Project T10/1760-D

Revision 14
28 January 2008

Information technology - Serial Attached SCSI - 2 (SAS-2)

Summary of Comments on Serial Attached SCSI - 2 (SAS-2) Standard

Figure 10 — SAS Domain class diagram

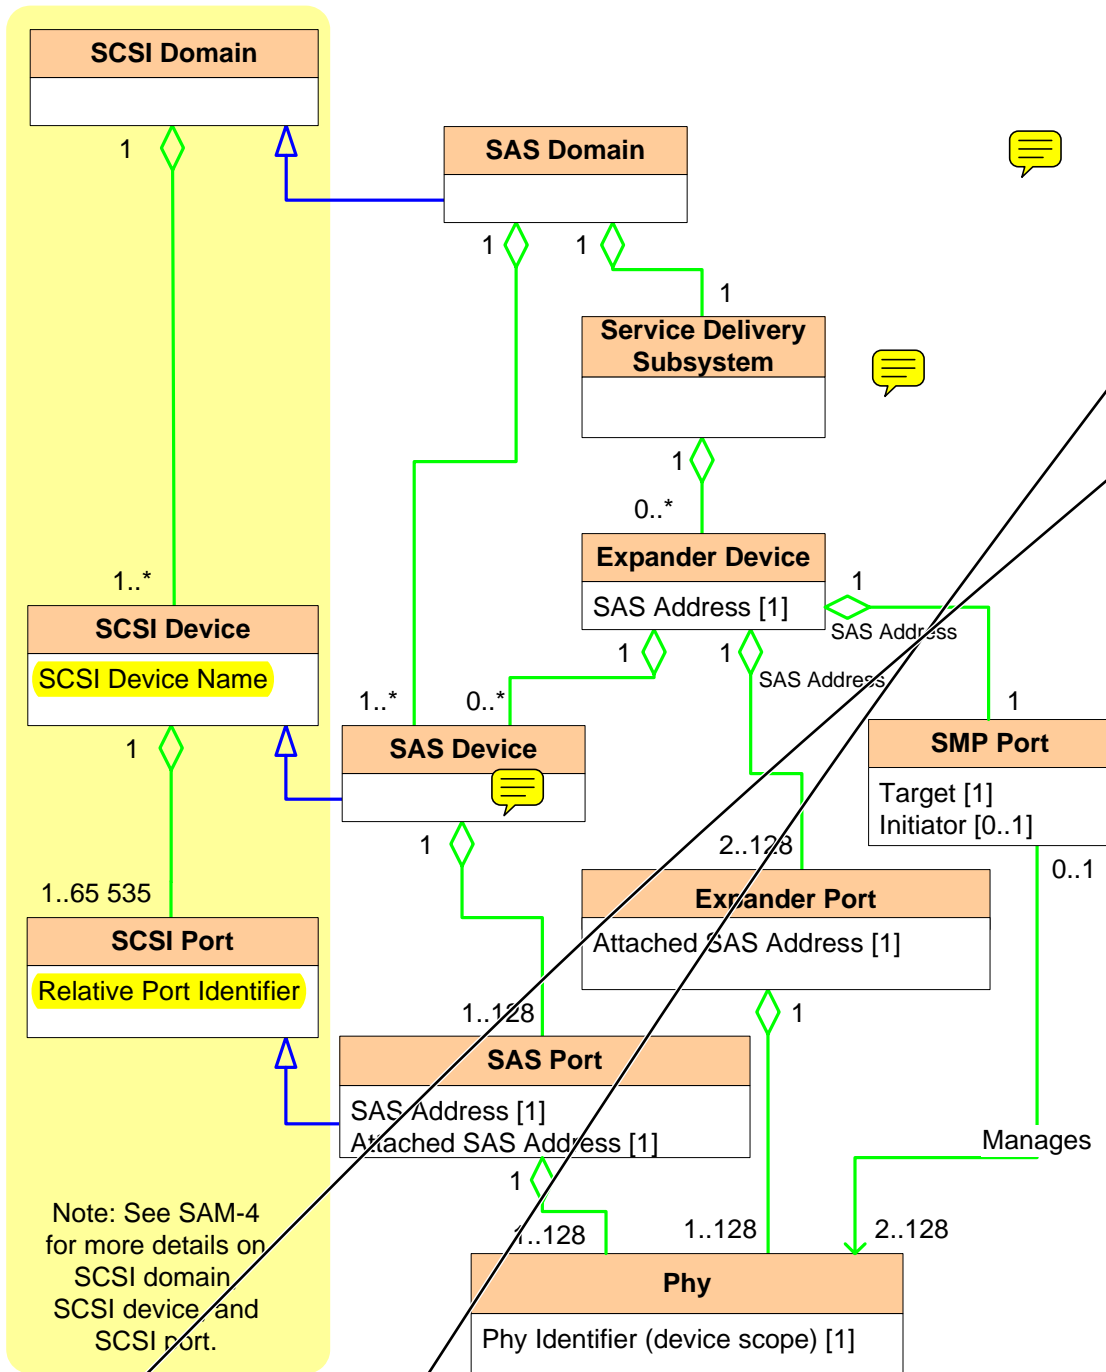
figure 10: changed 1..128 to 1..255

figure 10: changed 2.. to 2..255

Figure 16 — Port class diagram

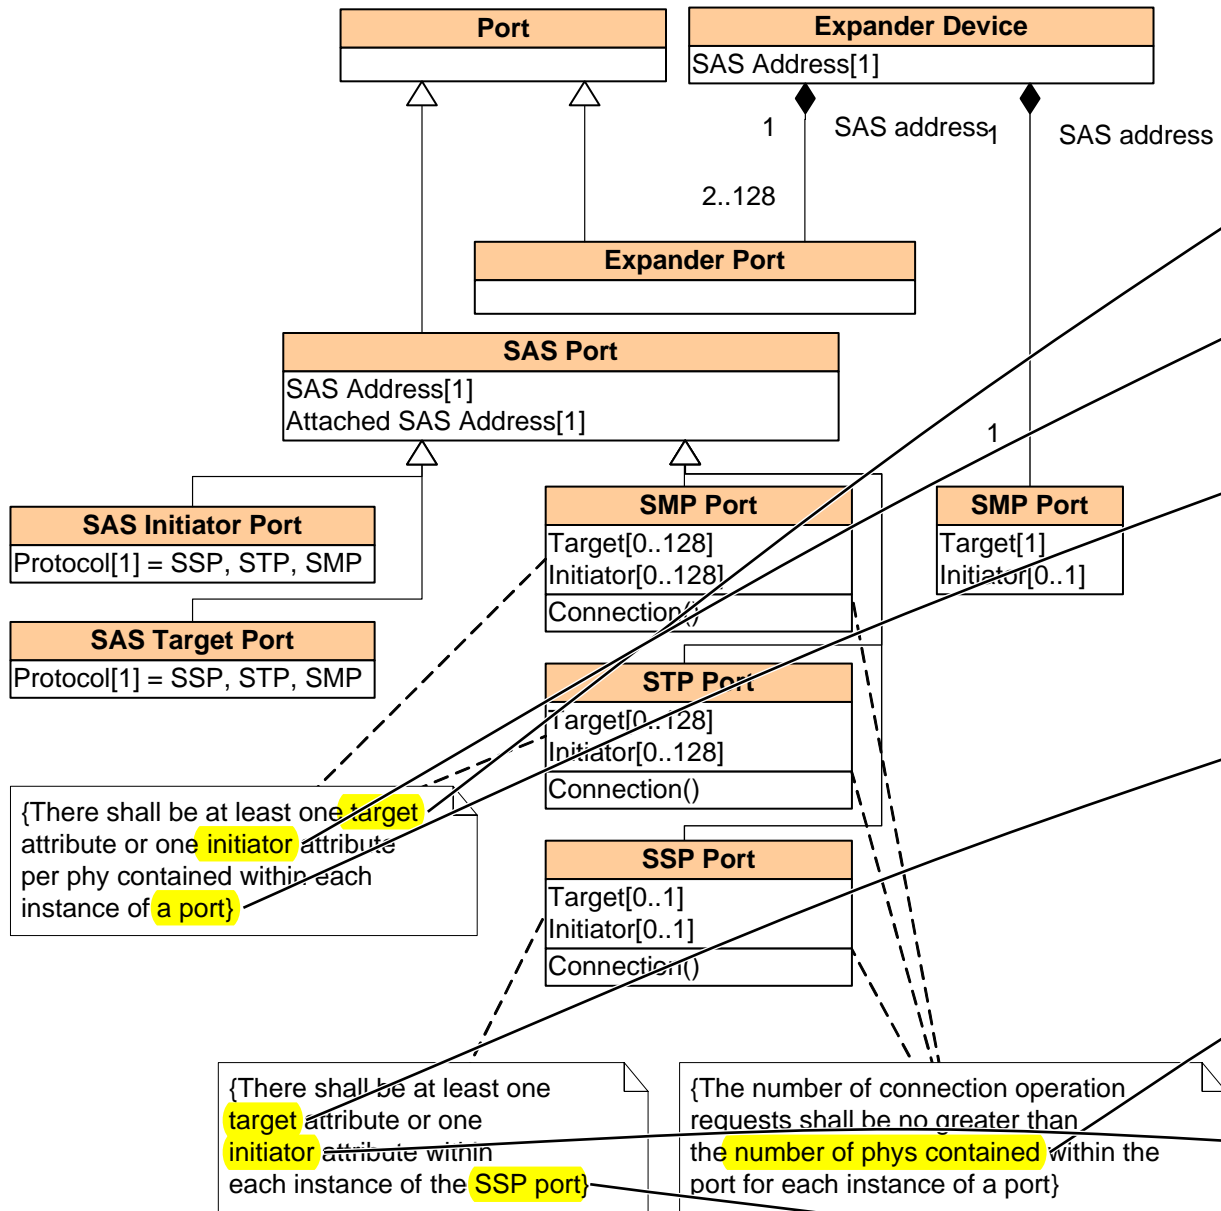
figure 16: changed [0..128] to [0..255] (zero to 255 possible phys)

figure 16: changed 2..128 to 2..255

Should be << detail is not shown. However, each port

Figure 28 — Multiple connections on wide ports

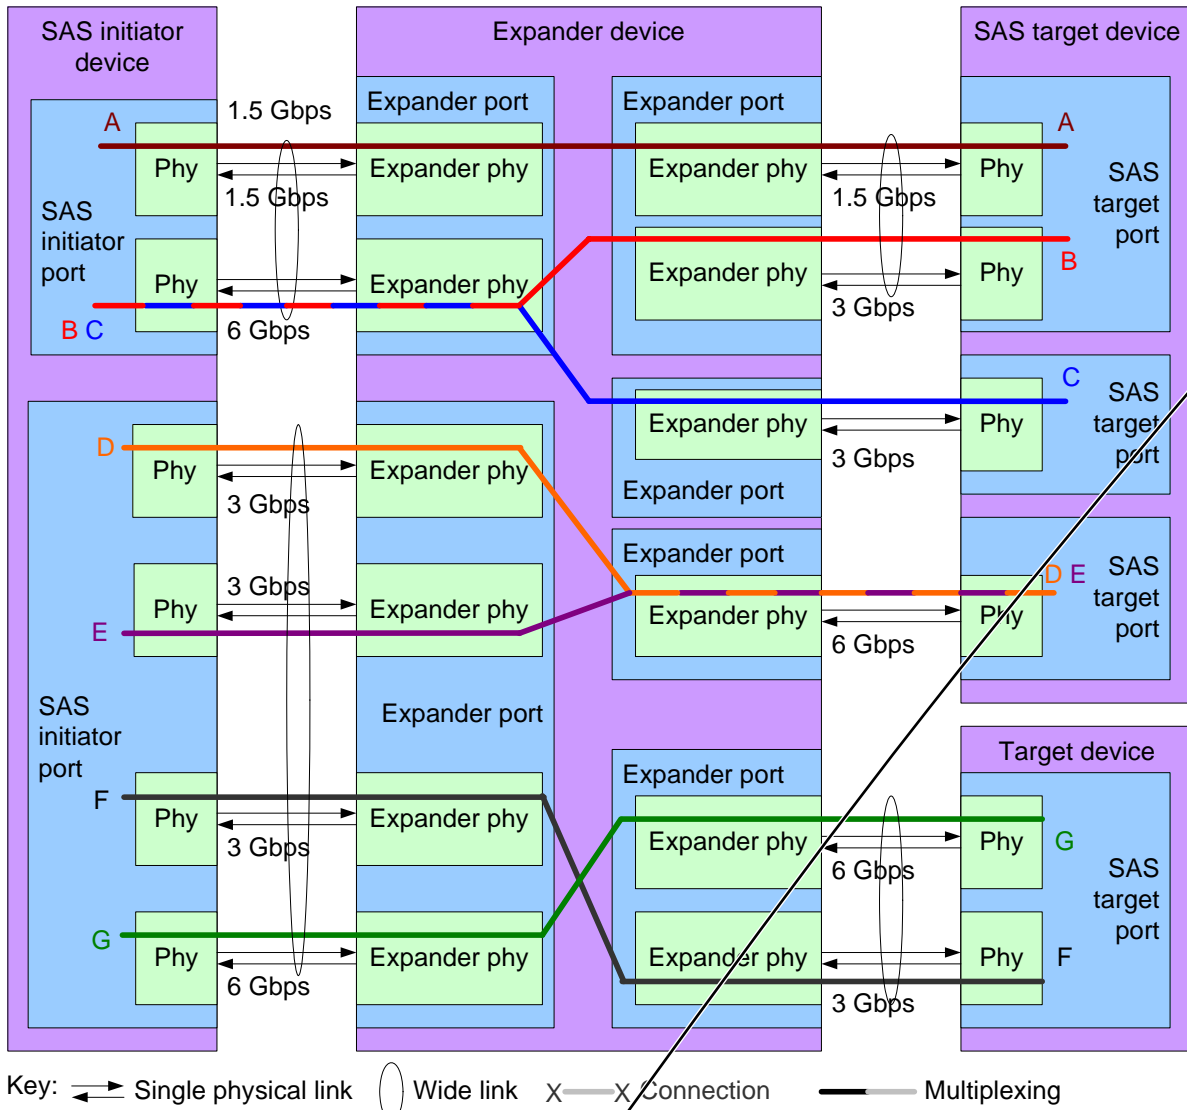
● Author: stx-goulder
Subject: Highlight
Date: 5/6/2008 4:07:48 PM

T ACCEPT - DONE (A, B, and C all originate from one initiator port, so should all be listed)
A and B

Figure 31 — Transmit data path in a SAS phy

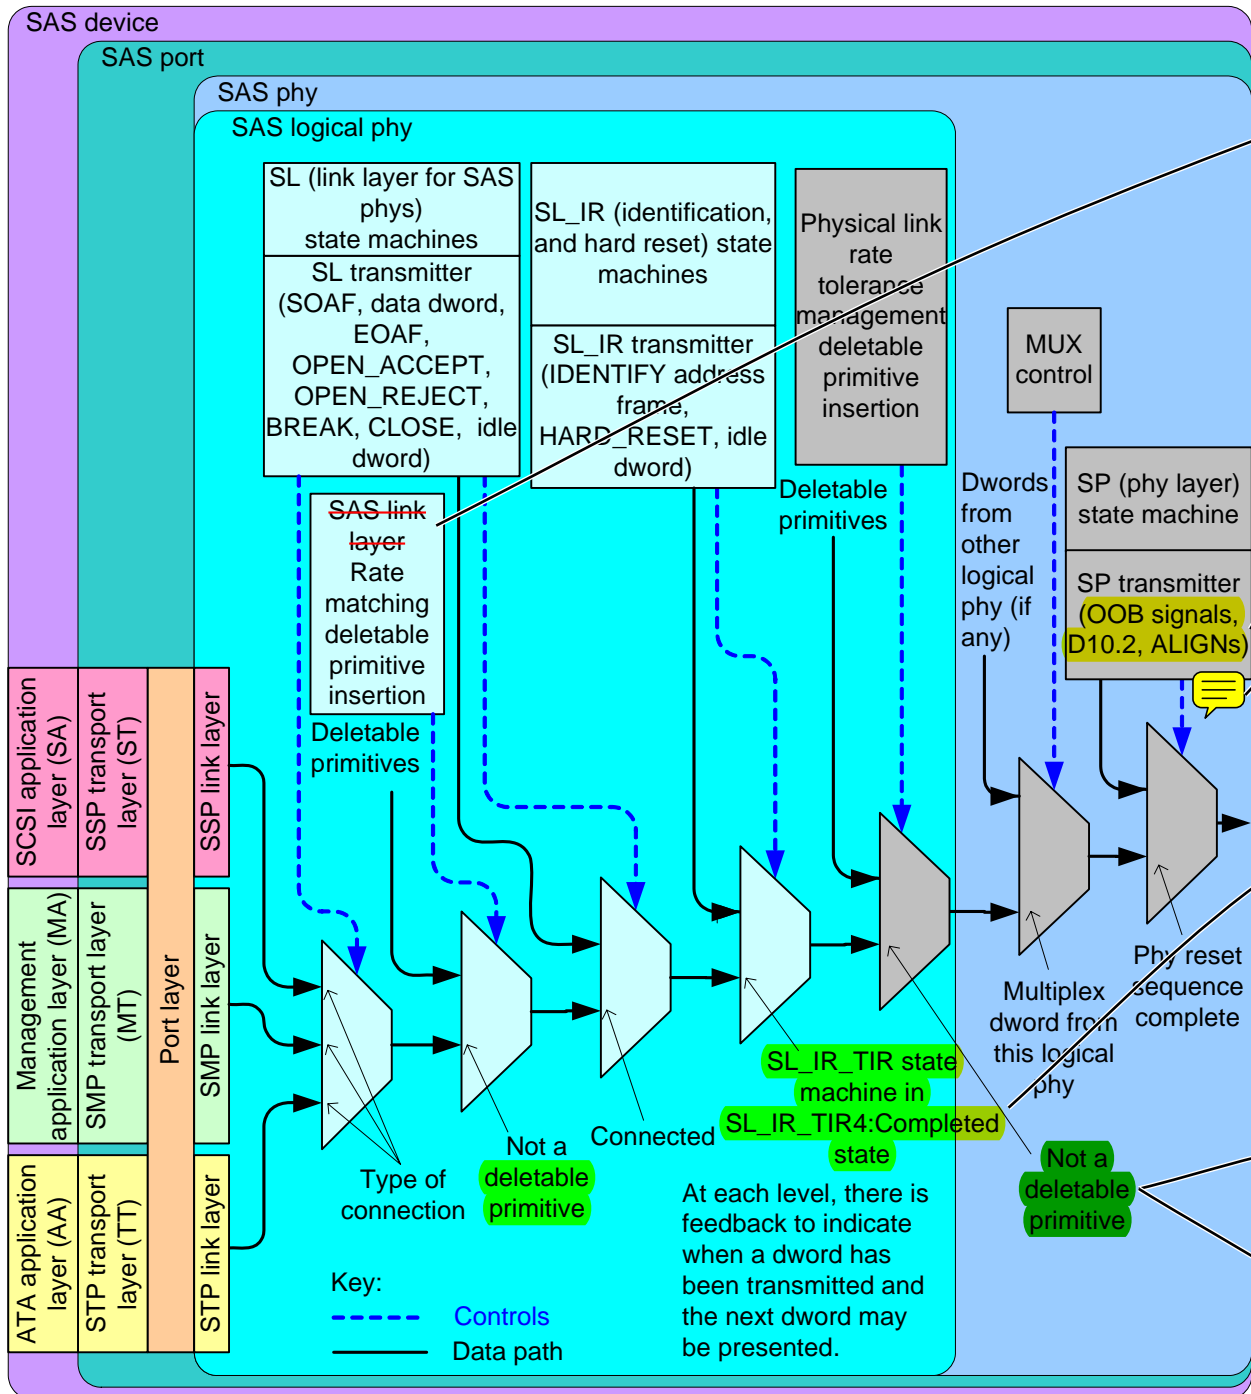
NOTE
s/b
Note

Figure 38 — State machines and SAS Device classes

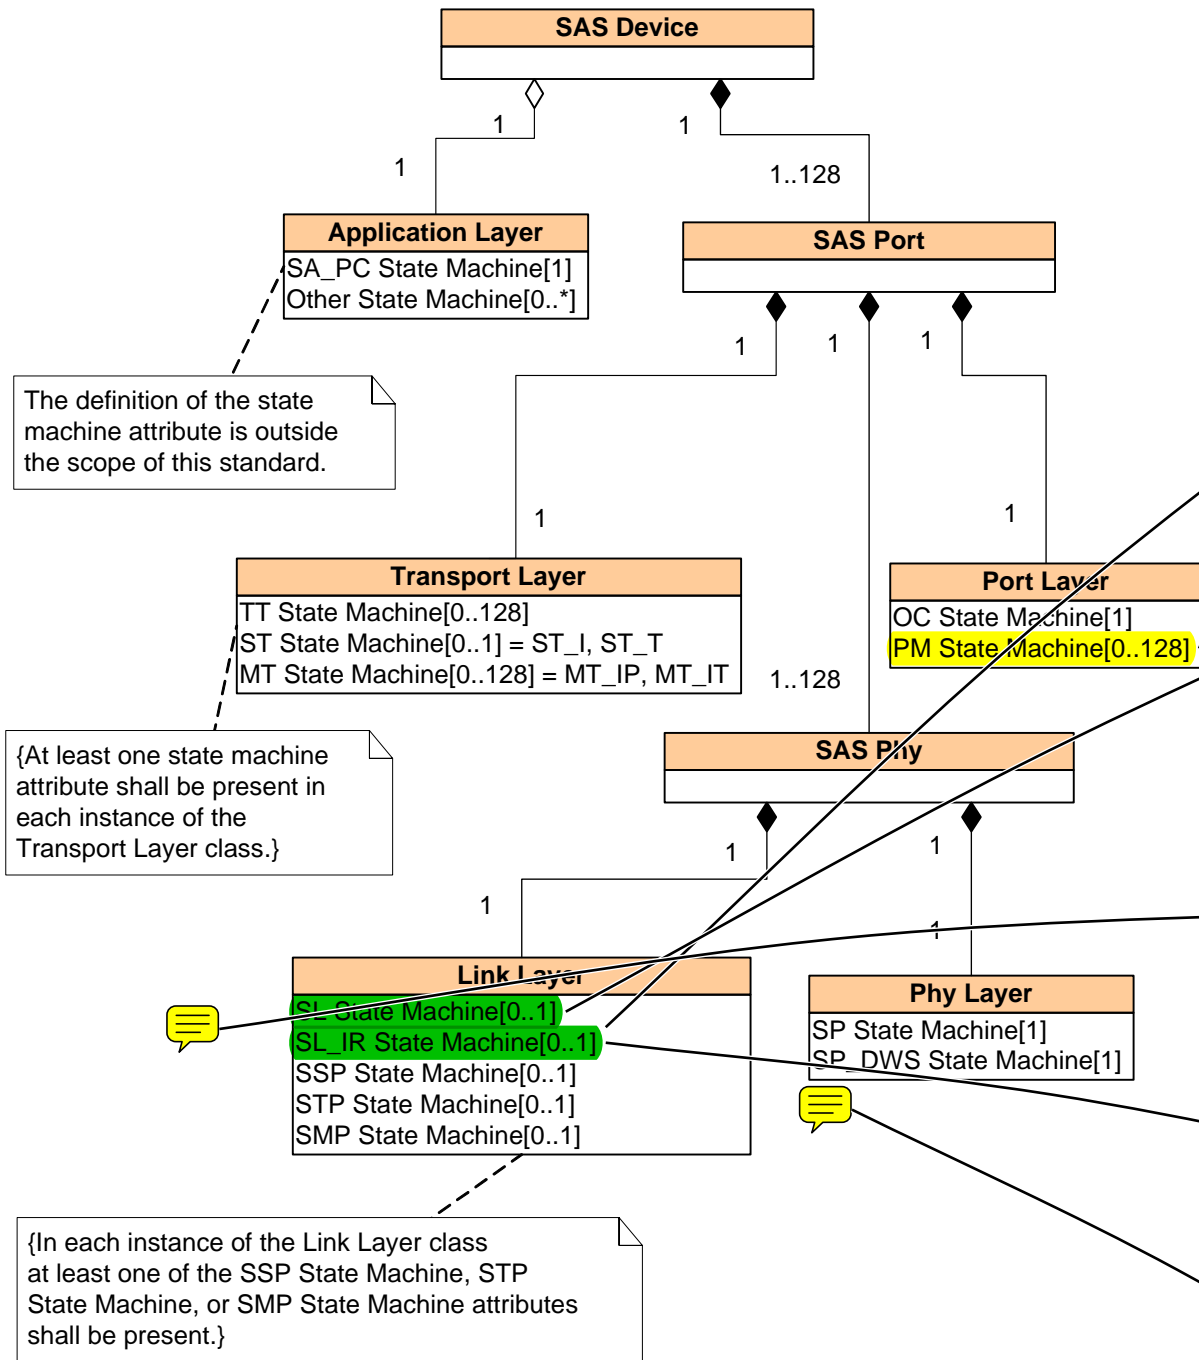
also figure 38: 0..128 to 0..255

also figure 38: 1..128 to 1..255

Figure 40 — Reset terminology

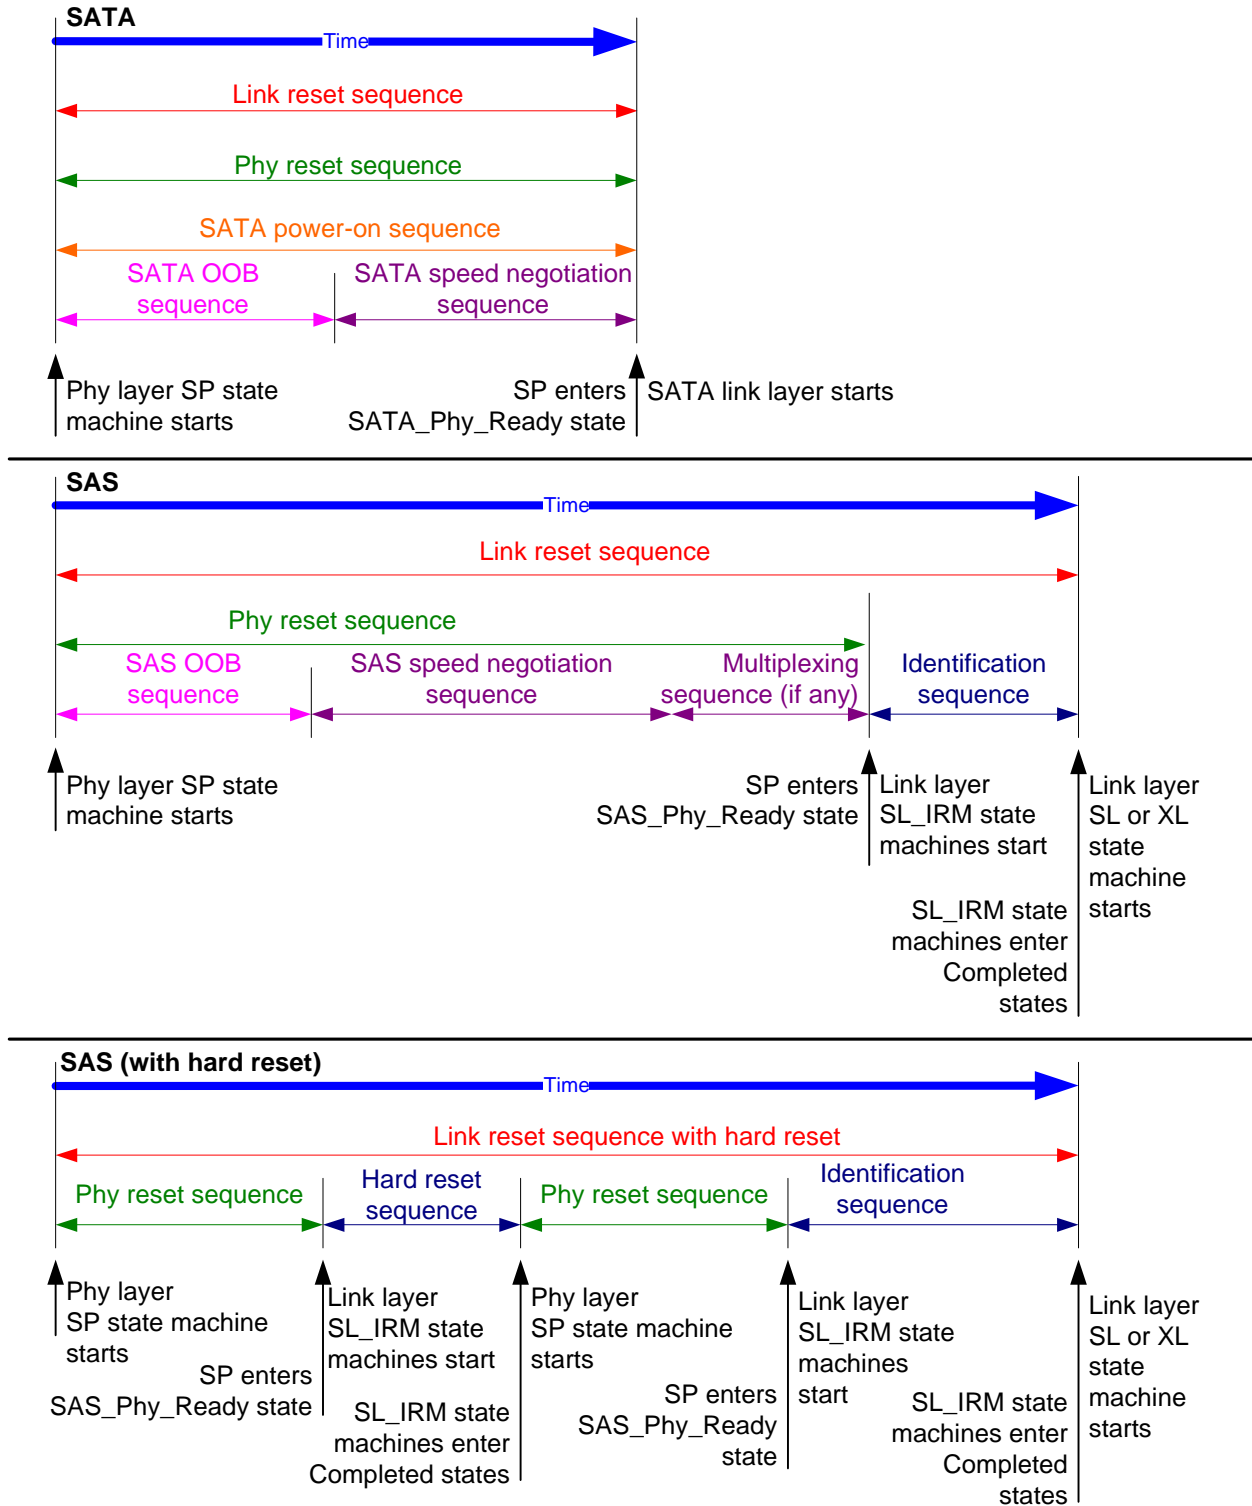
This figure does not show an SMP phy and associated link layer state machines below the SMP Port since figure 16 does not do so. If the expander allows more than one connection at a time to its SMP target port, then it's effectively a wide SMP port and has multiple phys and link layers. If it only allows one at a time, then it's effectively a narrow SMP port and only has one phy and link layer.

T ACCEPT - DONE (7/15 global change "illustrates" to "shows" in cases like this.)

Figure 50 — Expander route index order example

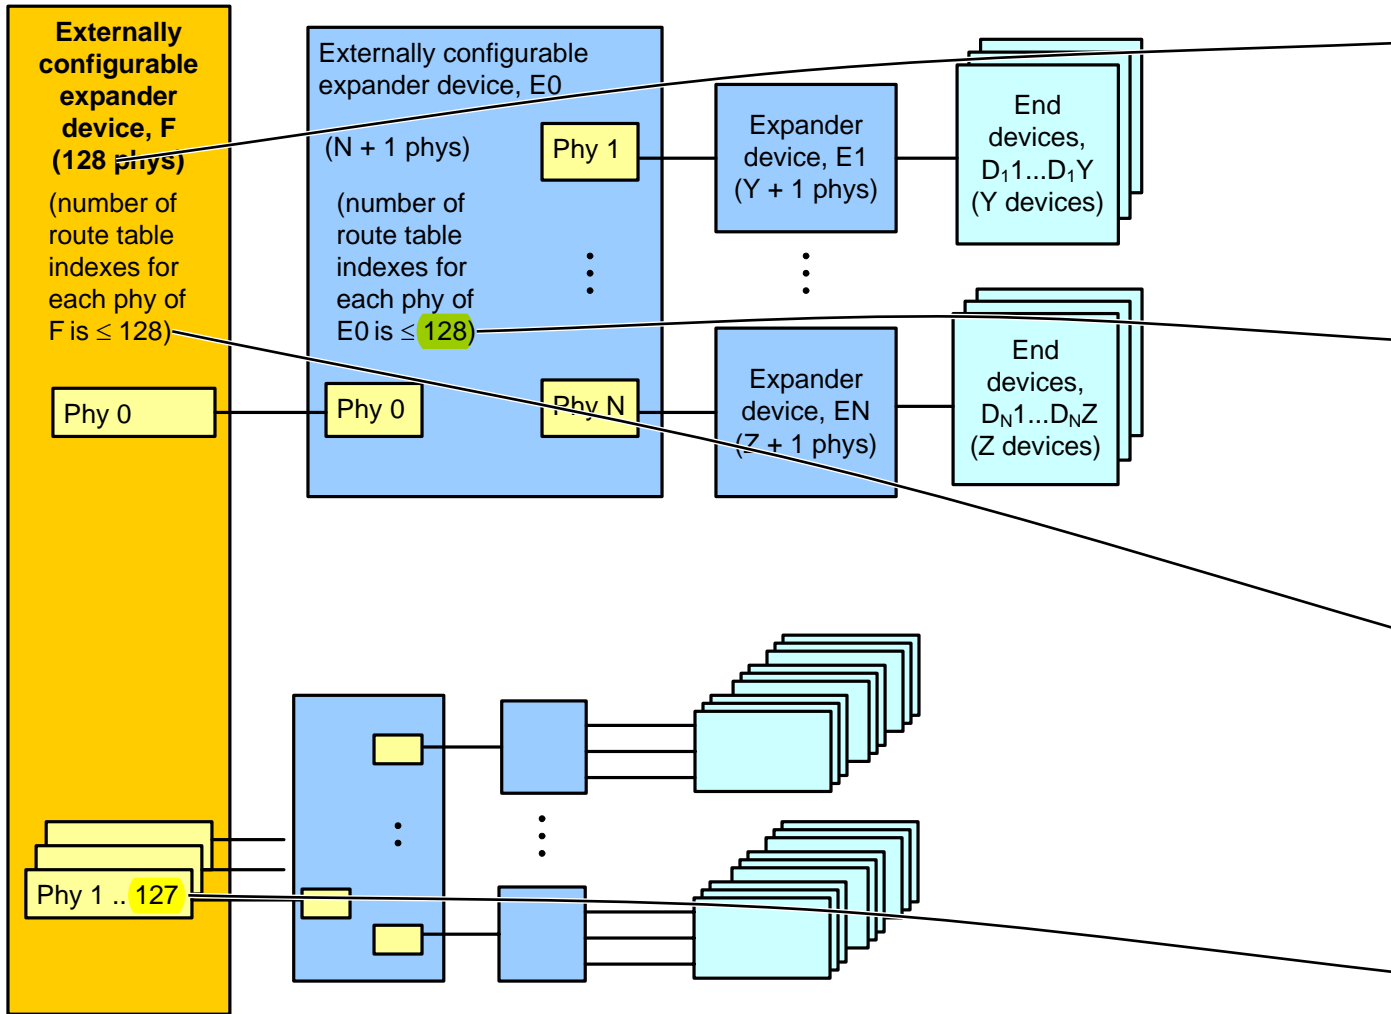
in figure 50, not table 50: 128 to 255, deleted two unnecessary sentences
